# Open Pit Continuation Project Open Pit Closure Design and Erosion Assessment

**NSW Resource Regulator request for information**

## **Cowal Gold Operations**

18 January 2024

**Figure 2-4: Rill Erosion on South-east Slope of Pit E42**

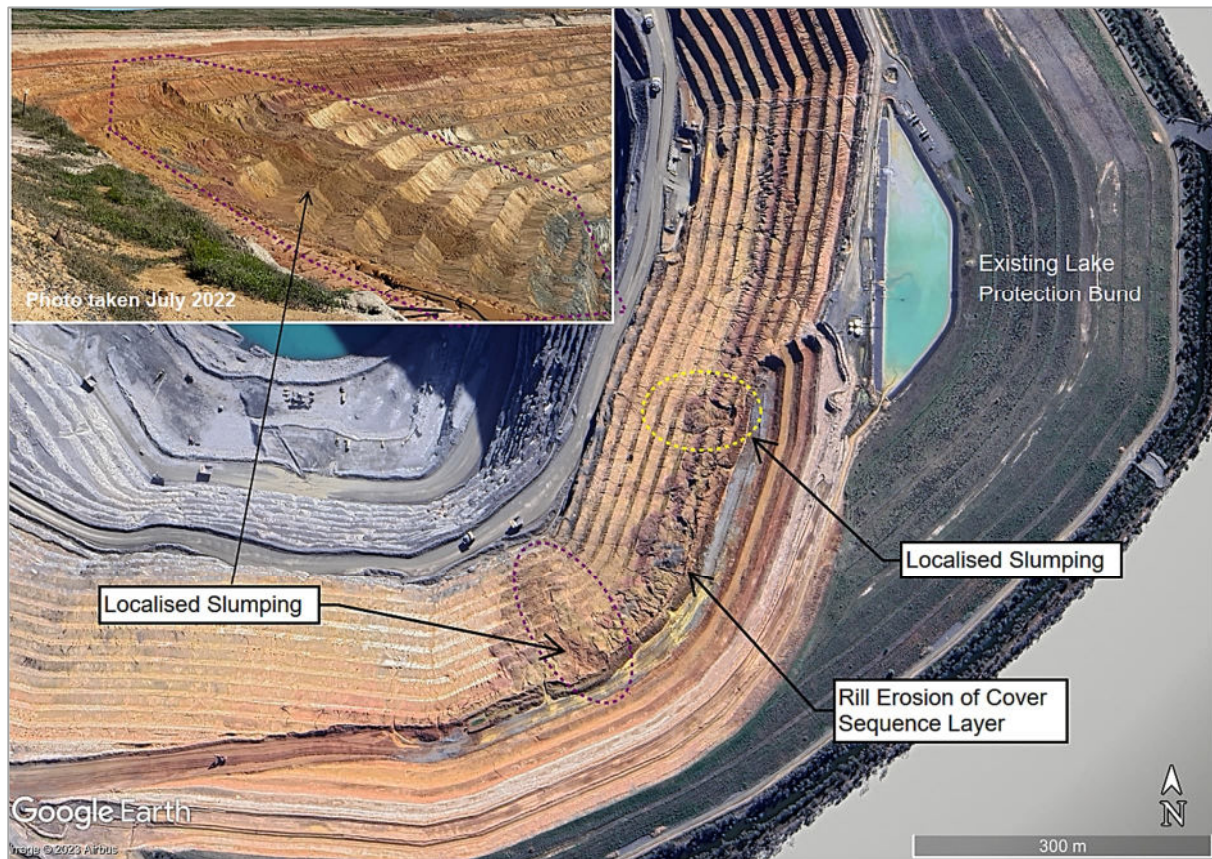
Based on pit survey data provided by CGO, the current E42 pit profiles range from 40° to 60° in the hard rock sections of the pit and approximately 25° in the overlying cover sequence. It is noted from the most recent Google Earth imagery, the presence of persistent erosion of the cover sequence layers exposed on the pit slopes (Refer **Figure 2-4**).

A site visit to CGO was undertaken by SLR in July 2022 as part of the design project for the proposed LPB. During a visit of pit E42 it was noted that the southeastern side of the pit was observed to have rill erosion in the cover sequence layer and there were some localised slumps originating in the eroded areas: this area of the open pit has since been remediated. Two examples of these slumps have been marked on **Figure 2-4** and the site photo inset.

The root cause of the slumps may have been caused by seepage permeating through the cover sequence from Lake Cowal, with the resulting increased pore pressure and soil saturation causing the localised slope failures: localised slope failure could also be due to weathering and residual structure in the oxidised material. The raised pore pressure conditions are considered to be a temporary case which develop during times of intense rainfall which recharges nearby catchments such as Lake Cowal.

**Figure 2-6: Surface runoff to the pit wall from the pit crest (Nearmap, 2021)**

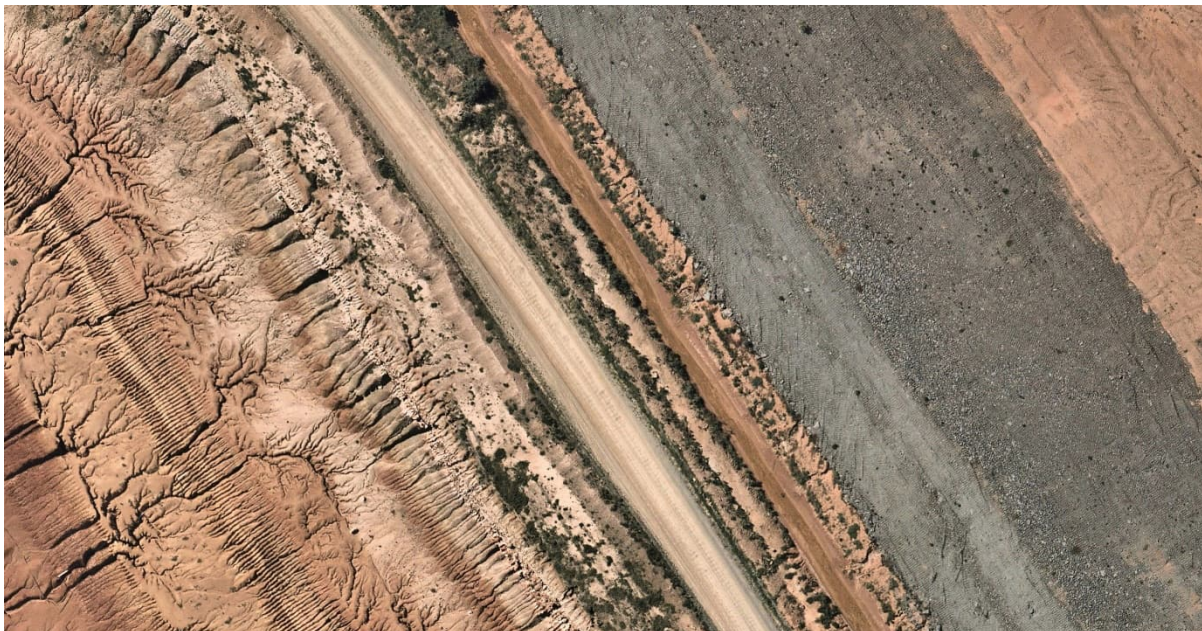
There is a drainage system around the crest of E42 on the edge of the perimeter road. However, during heavy rainfall, the drainage system is not adequately controlling water from the crest. This is leading to some erosion from the crest of the open pit down the full length of the exposed berms and benches on the pit walls which is increasing surface erosion and facilitating small, localised slumps.

As the E41 Pit is developed, as part of the OPC Project, to the south of E42, the shoulder between the pits will be removed; this will include the upper section of the eroded areas of berms and benches in the E42 pit, allowing CGO to re-design the operational draining system in this area to reduce this current problem.

At the end of mining, all surface runoff within the mine site is to be directed into the E42 open pit. Surface water will be directed around the pit crest (stopping surface flow down the oxide zone of the pit walls) and down the main haul road that will be developed to include a suitable sized and engineered drainage system. The drainage system constructed within the oxide zone must be able to contain the flow and be built in such a way that the base of the surface drains does not develop cracks in the oxide material that would enable water in the drains to flow back into the oxide material.

Figure 2-7: Horizontal dewatering can produce near continual seeps that could lead to erosion (Nearmap, 2021)

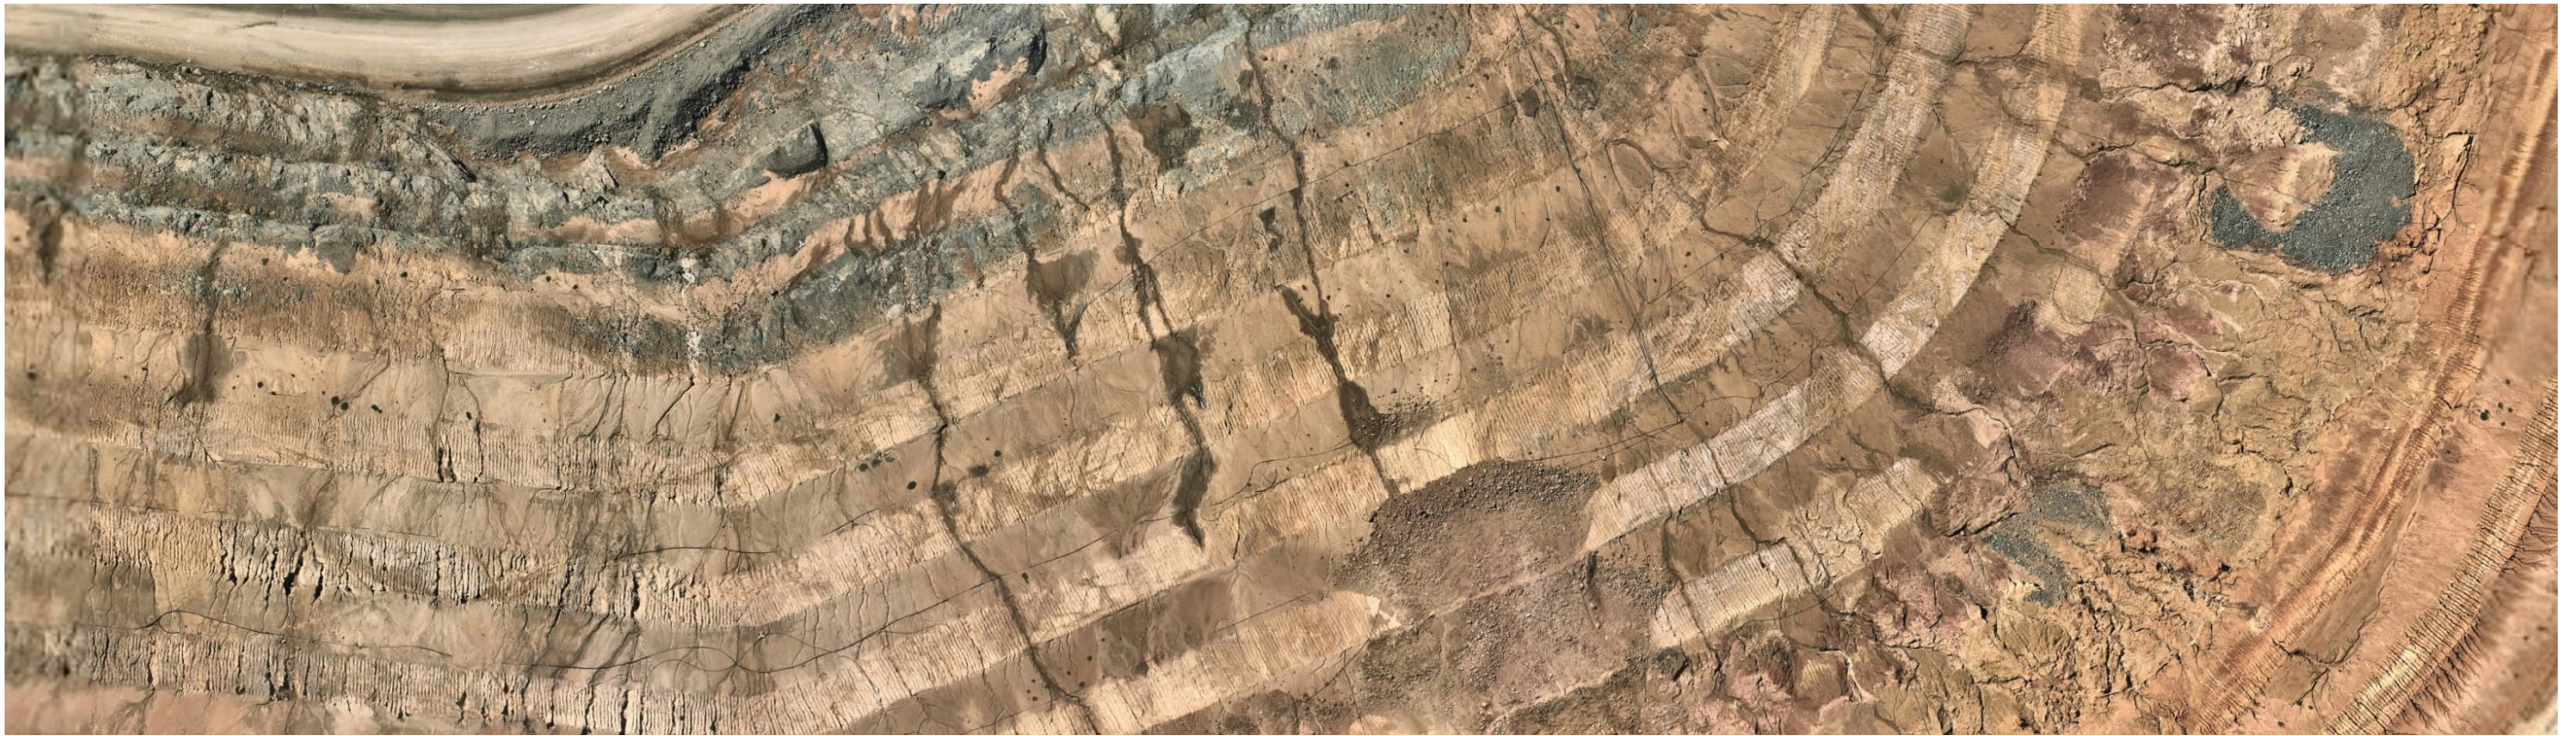
Conversely the horizontal dewatering piezometers can become point sources for seeps that could cause erosion (**Figure 2-7**). CGO has connected the horizontal piezometers to pipes to collect the seepage and reduce erosion (**Figure 2-8**).

- SLR would be asking how the effectiveness of the bores has been determined?
- Is the structural orientation of the oxide zone clearly defined and presented in a 3D structural model to optimise sub horizontal borehole design?

- Intercepting interconnecting permeable structures will give the best chance of depressurising these slopes. Otherwise, dewatering slopes with a high clay content is likely to require an uneconomic number of closely spaced bore holes to be effective. Again, it would be useful to see the evidence for the effectiveness of the currently existing boreholes.

Figure 2-8 Horizontal seeps have been connected to pipes to reduce erosion risk (Nearmap, 2021)

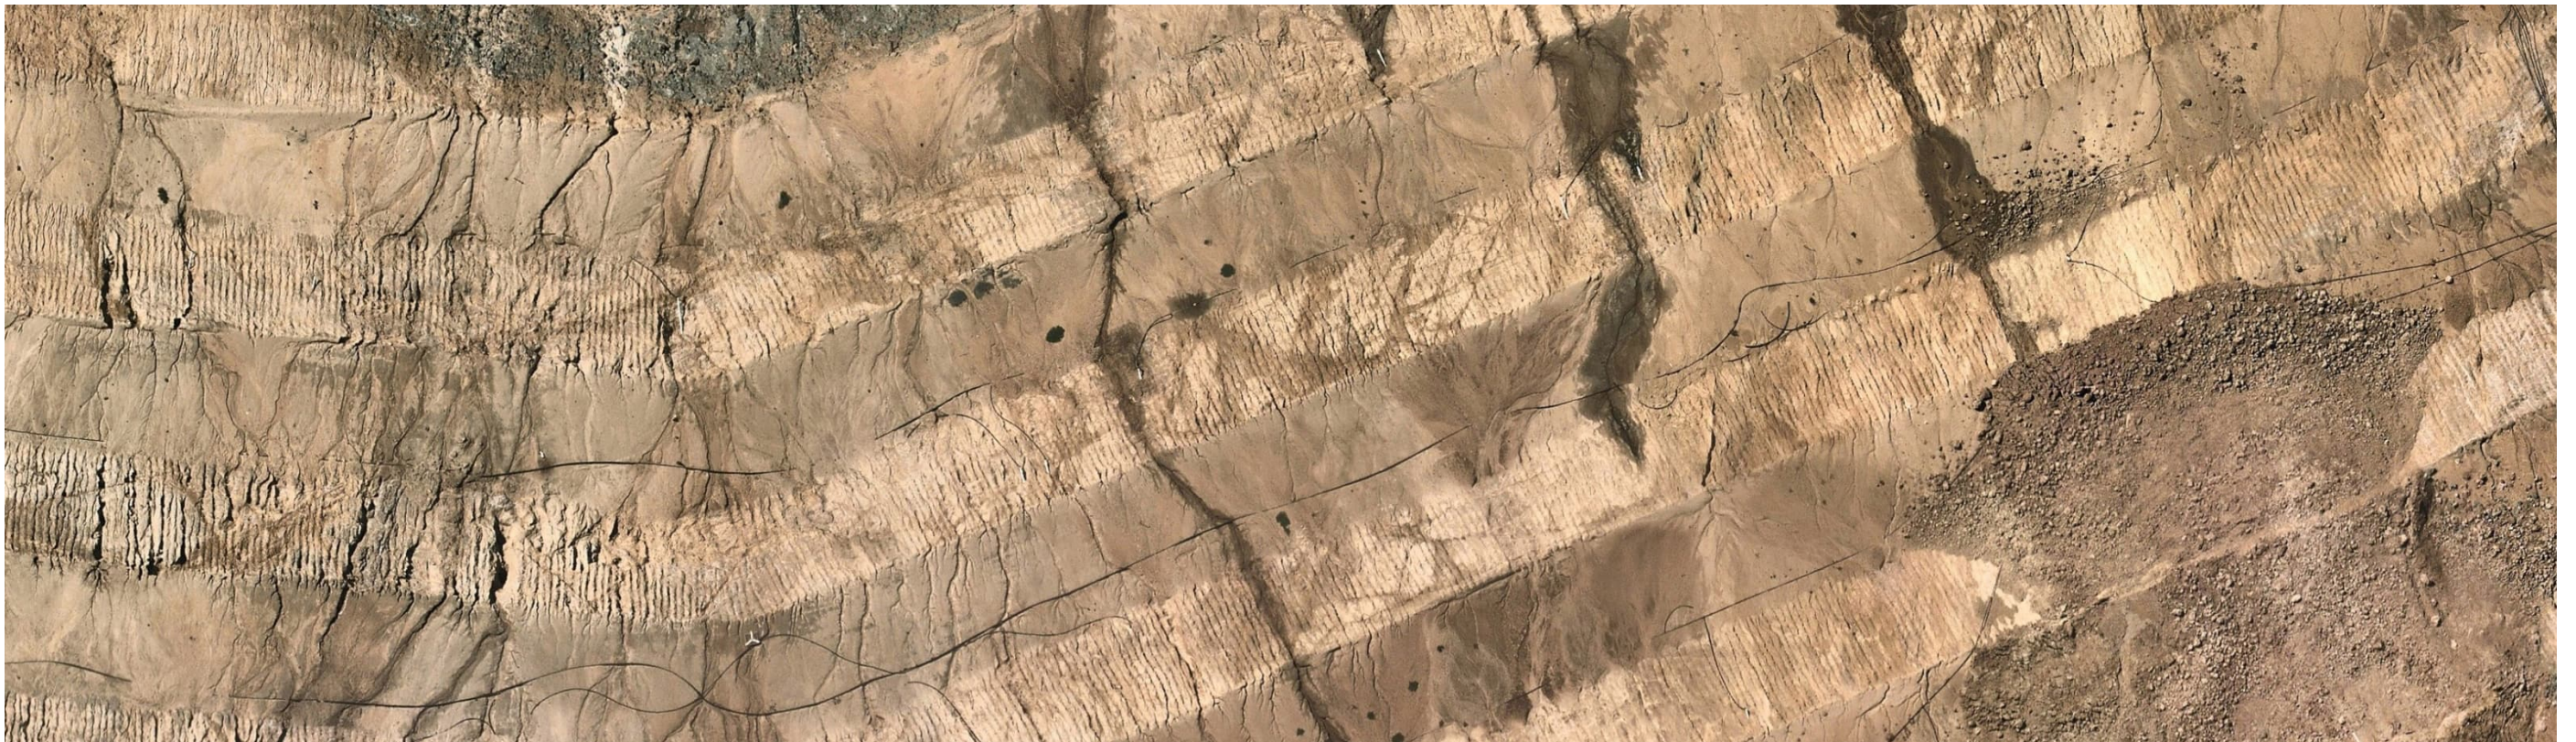
- It is unclear how the existing bore holes in the oxide zone of the pit wall will be decommissioned and then reinstated during the pit wall cut back in E42.

- It is unclear if the dewatering bores will need to be maintained post closure to maximise pit wall stability, and if they are required to be maintained, how this will be done.
